NUMBER
DPS1326

SOLICITATION NUMBER: DPS1326**Addendum Number: 1**

REQUEST FOR QUOTATION
[DPS 1326] Lightbars and Sirens

EXHIBIT #1

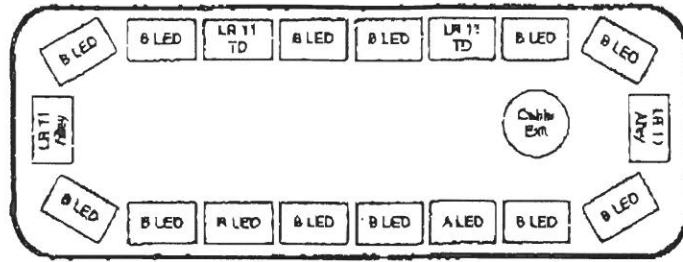
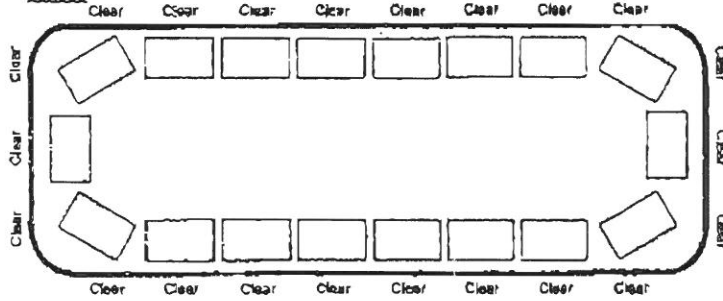
1. Responses to vendor questions attached
2. Diagram to show actual positioning attached. See Exhibit #1
3. The bid opening remains 11/13/2013 at 1:30 pm.

Liberty Series Light Bar Order Form/Worksheet
